# HISTORIC AND DESIGN REVIEW COMMISSION

**HDRC CASE NO:** 2020-135  
**ADDRESS:** 607 HEMISFAIR BLVD  
**LEGAL DESCRIPTION:** NCB 13814 BLK 3 LOT 15 (HEMISFAIR SUBD)  
**ZONING:** D, H, RIO-3  
**CITY COUNCIL DIST.:** 1  
**DISTRICT:** Hemisfair Historic District  
**APPLICANT:** Davis Sprinkle/Sprinkle & Co. Architects  
**OWNER:** Hemisfair Park Area Redev Mr. Andujar/CITY OF SAN ANTONIO  
**TYPE OF WORK:** Rehabilitation with the construction of a rear addition  
**APPLICATION RECEIVED:** March 13, 2020  
**60-DAY REVIEW:** May 12, 2020  
**CASE MANAGER:** Edward Hall

## REQUEST:

SITE PLAN

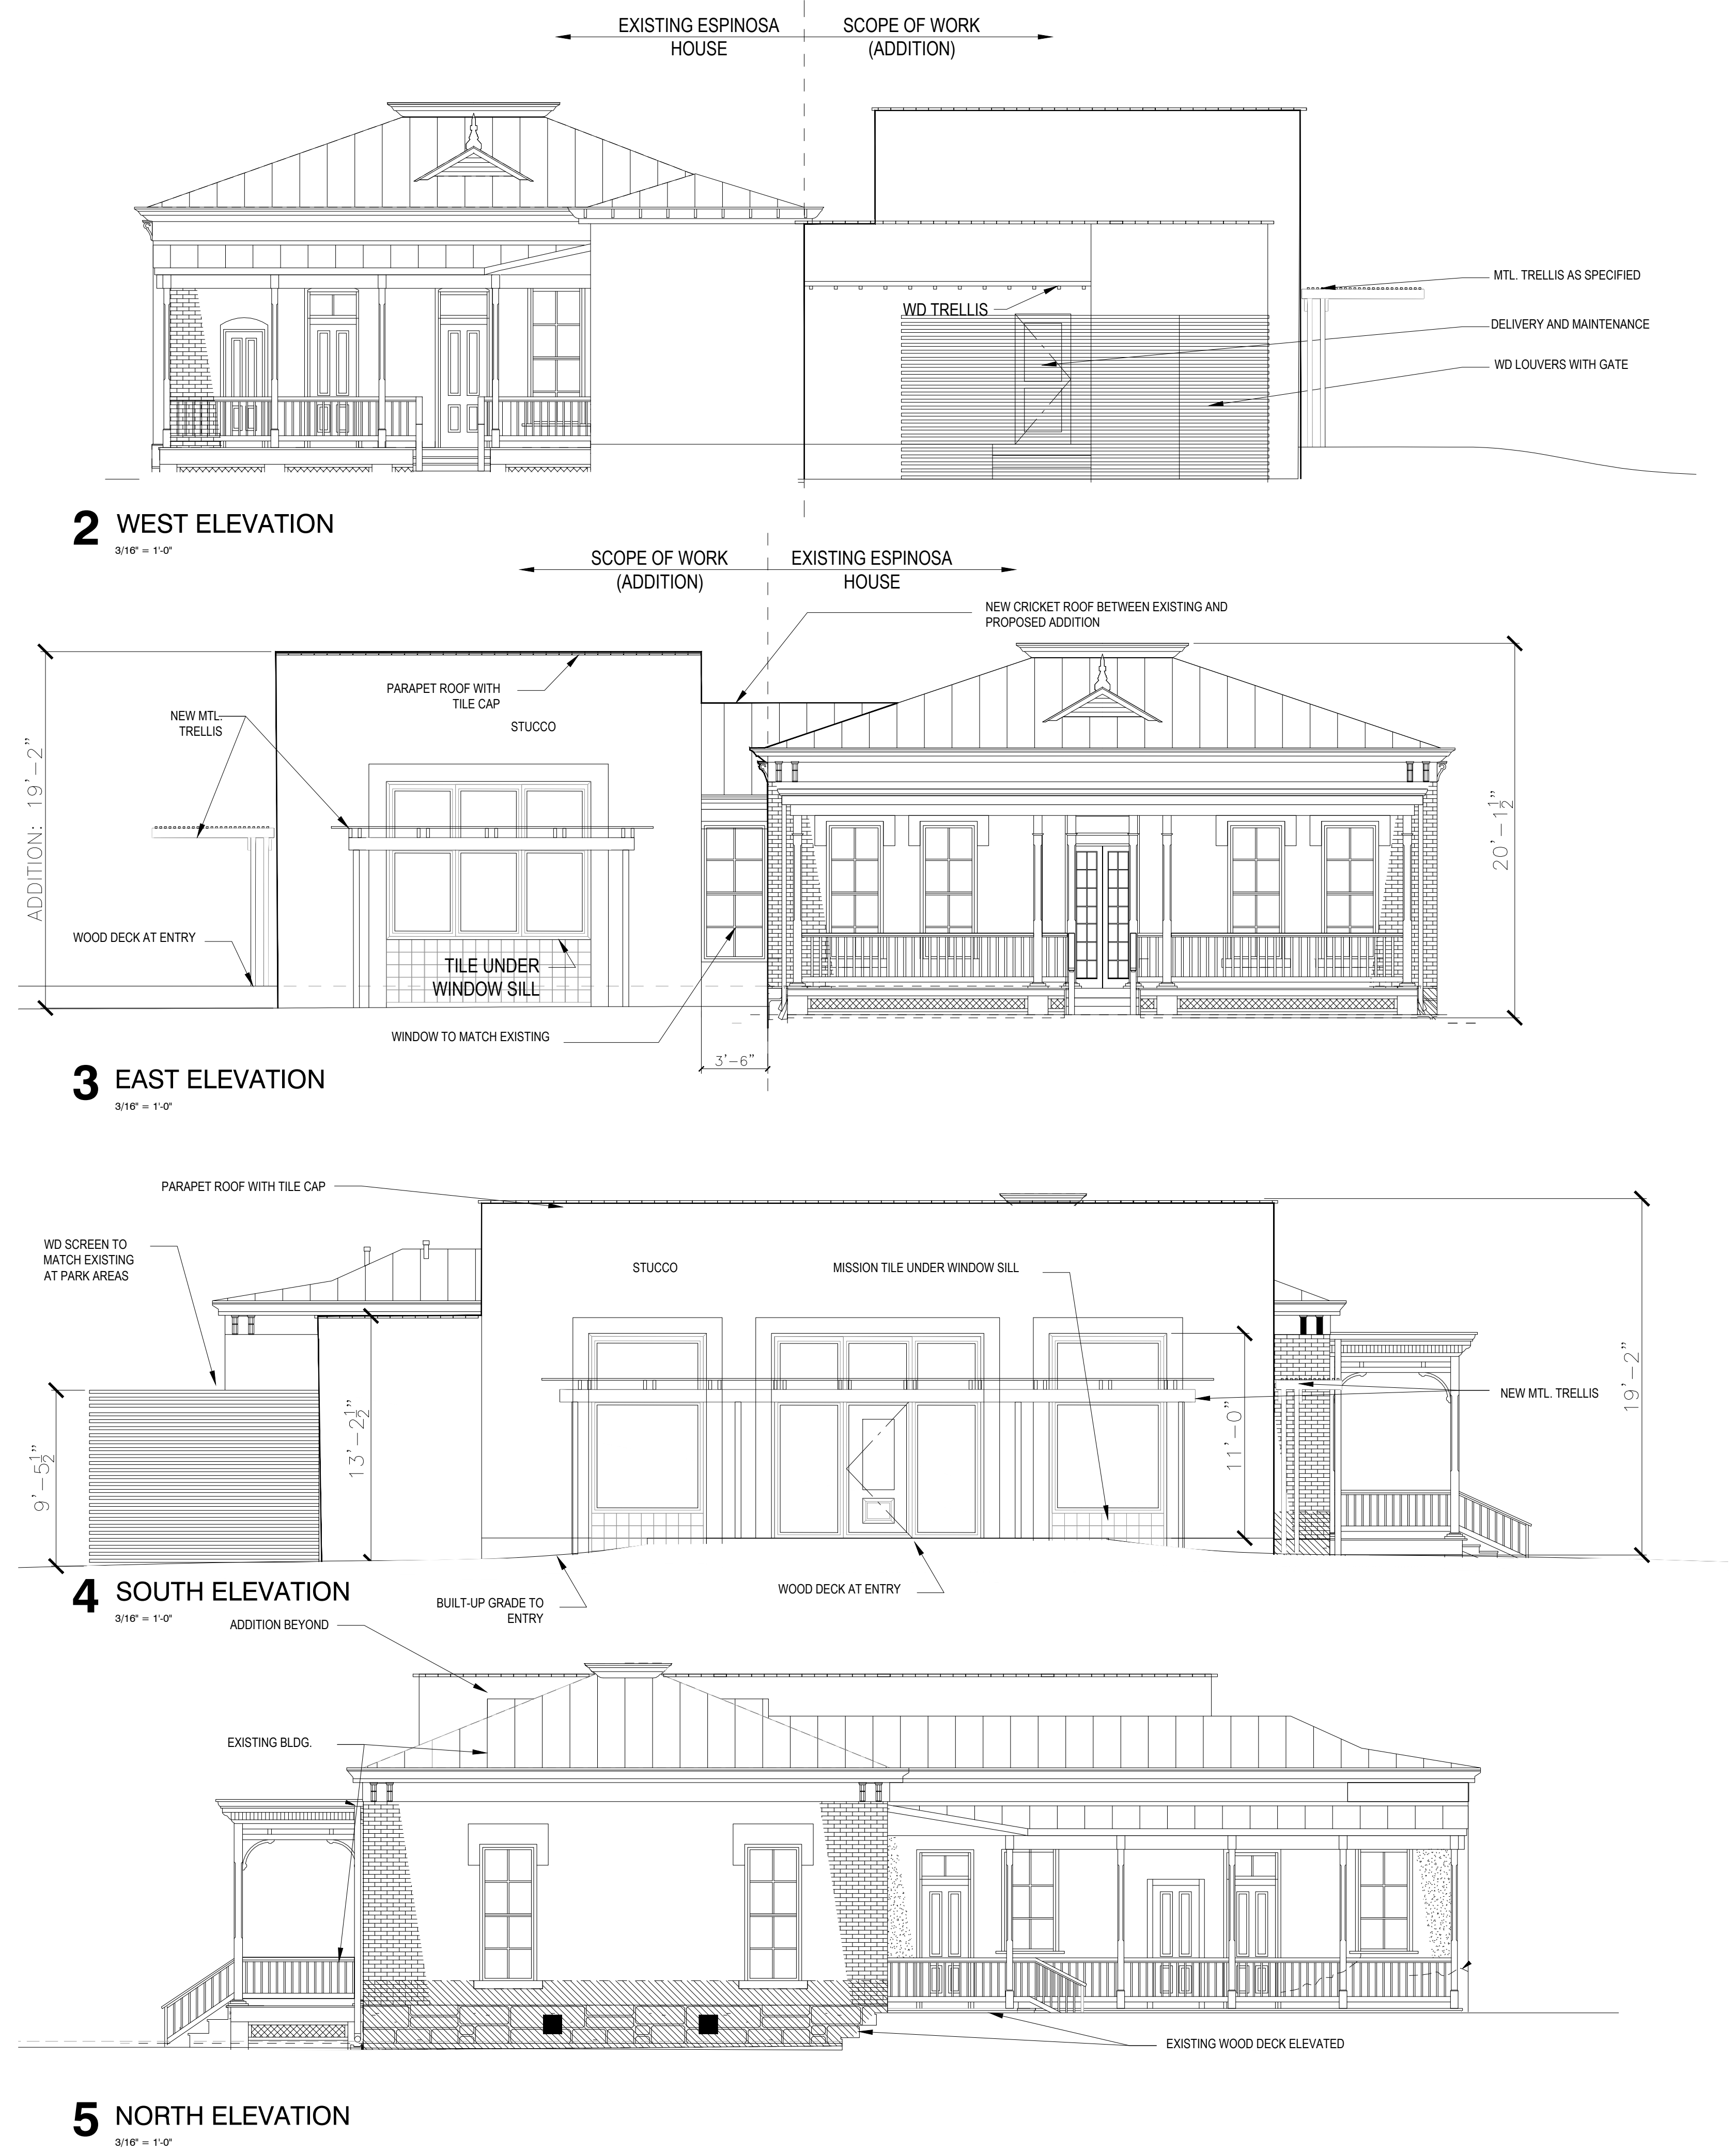
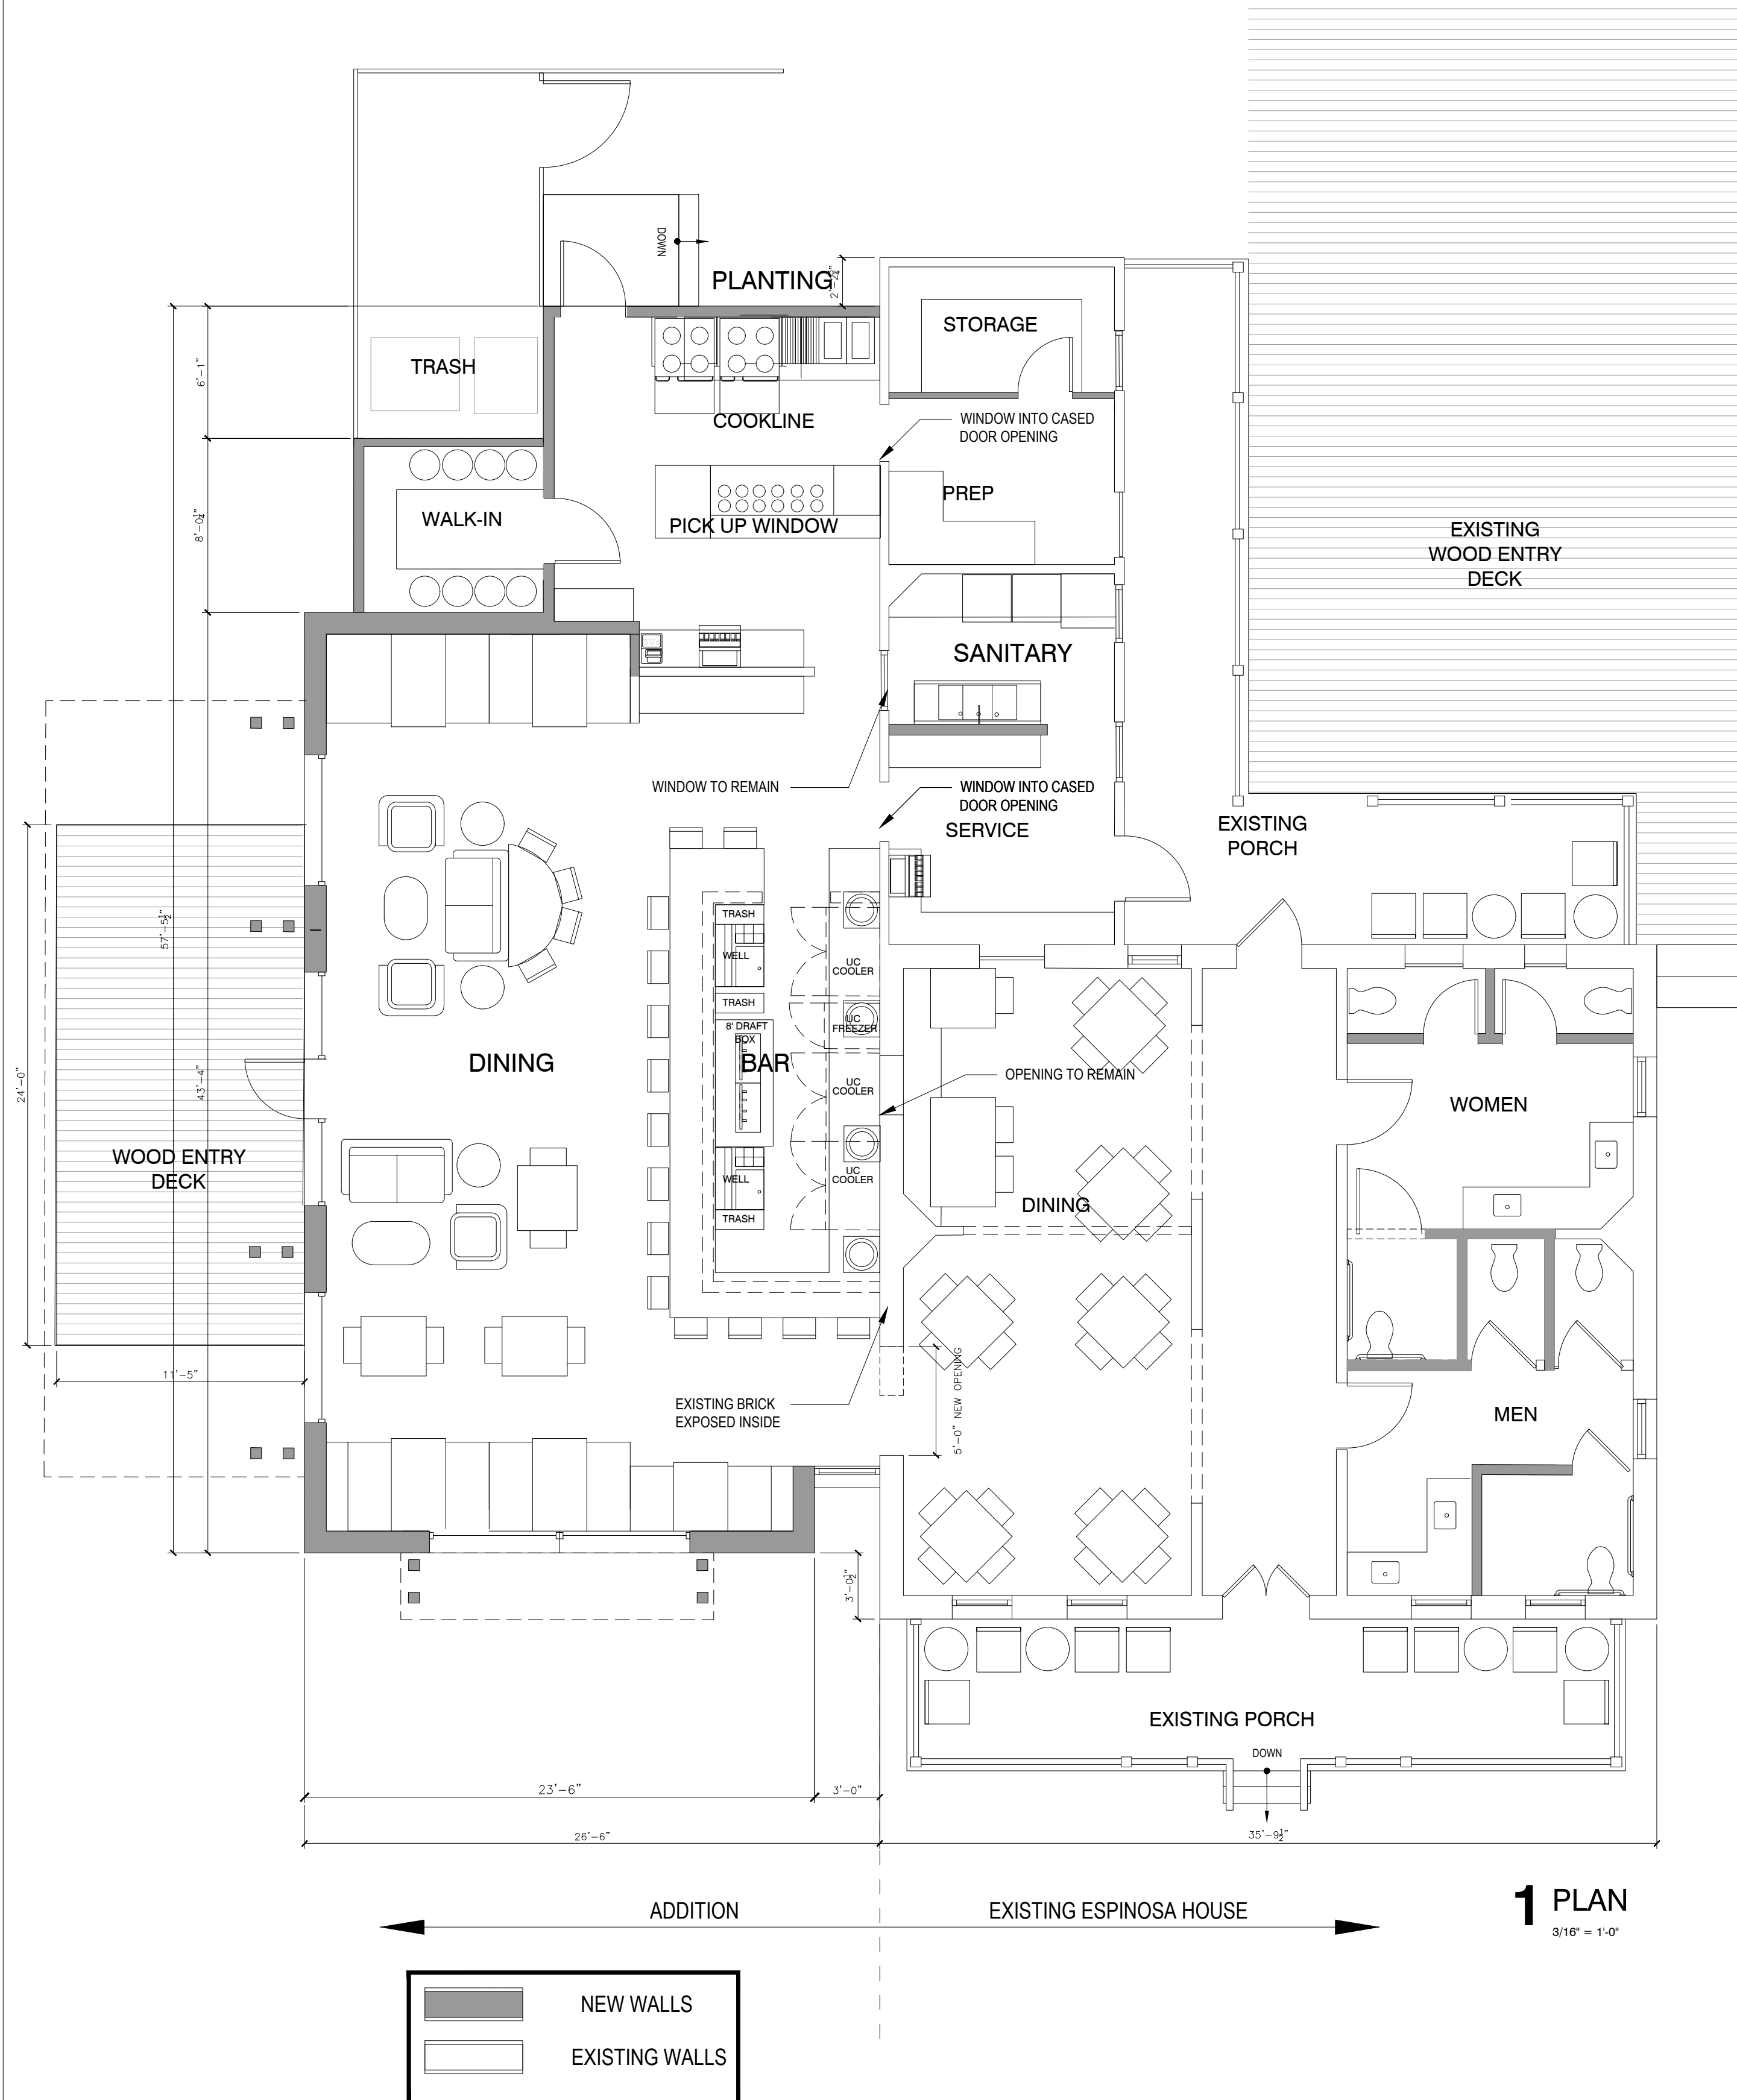
- c. **SCALE, MASS & FORM** – The Guidelines for Additions 2.B. notes that the height of side additions should be limited to that of the original structure, and that the proposed footprint should not result in the doubling of the historic building's footprint. The applicant has proposed an overall height that is approximately one (1) foot less than that of the historic structure's, and an overall footprint that is greater than that of the historic structure's by approximately sixty-five (65) square feet. While the proposed footprint is greater than that which is recommended by the

Guidelines, staff finds that its location is appropriate. Staff finds that given the proposed footprint, a reduction in height of the proposed new construction should be incorporated into the design.

- i. That the applicant reduce the overall height of the proposed addition to appear subordinate to the historic structure.
- ii. That the applicant eliminate the proposed terra cotta tile parapet cap.
- iii. That all mechanical equipment be screened from view from the public right of way as noted in finding f.
- iv. **ARCHAEOLOGY** – Archaeological investigations are required. The project shall comply with all federal, state, and local laws, rules, and regulations regarding archaeology, as applicable.
